Re: St. Lucie Unit 1  
Docket No. 50-335

Power Dependent Insertion Limit Curve

The purpose of this letter is to correct a minor error in Technical Specification Figure 3.1-2 ("CEA Insertion Limits vs. Thermal Power with 4 Reactor Coolant Pumps Operating"). The sequence of events leading to the error were as follows:

Figure 3.1-2 CEA Insertion Limits vs THERMAL POWER with 4 Reactor Coolant Pumps Operating

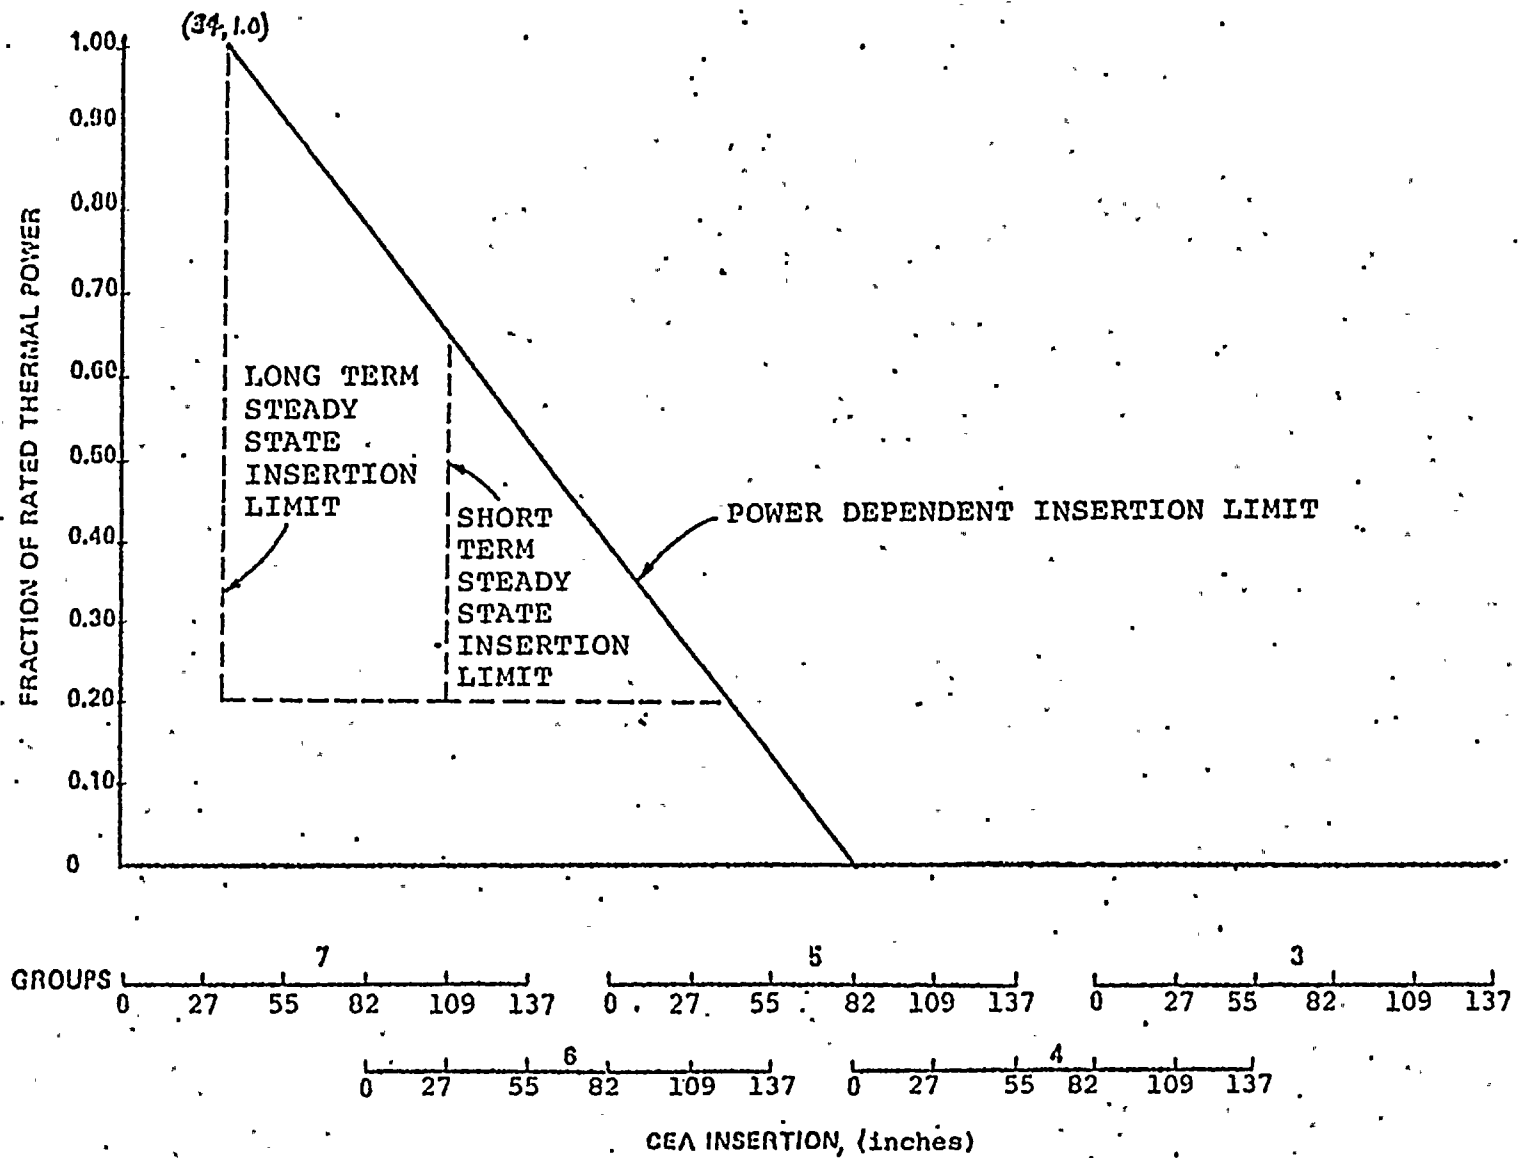
In order to make the curve consistent with the existing Technical Specifications and easier to use, the "CEA Insertion" scale was changed from per cent to inches. The coordinates in the upper left corner of the figure should have been changed from (25,1.0) to (34,1.0), but this was overlooked. The actual position of the PDIL curve was correct; that is, the full power insertion limit corresponded to 34 inches (25% of 137 inches) on the "CEA Insertion" scale, but the abscissa was not changed as it should have been.

The RSE was submitted on March 22, 1978, and the NRC approved numerous Cycle 2 Technical Specification changes by issuing Amendment 27 to Operating License DPR-67 on May 26, 1978. Figure 3.1-2 was issued with the (25,1.0) coordinates intact, but the PDIL curve had been positioned such that, at full power, it corresponded to 25 inches on the "CEA Insertion" scale. The correct curve, as supported by the RSE, should have been positioned such that the full power limit corresponded to 34 inches and the coordinates in the upper left corner read (34,1.0). A corrected Figure 3.1-2 is attached.

Figure 3.1-2 as issued by Amendment 27 is conservative in that it limits Group 7 insertion at full power to 25 inches rather than 34 inches. Since Group 7 is used to dampen Xenon oscillations, the conservative PDIL limit decreases operating flexibility. Limiting Group 7 insertion to 25 inches could permit a situation where power would be limited during a Xenon oscillation because compensating rod insertion past 25 inches would be prohibited. In order to correct our error, and to gain operating flexibility, we request that Figure 3.1-2 be reissued to conform with the attached corrected figure. Your assistance will be appreciated.
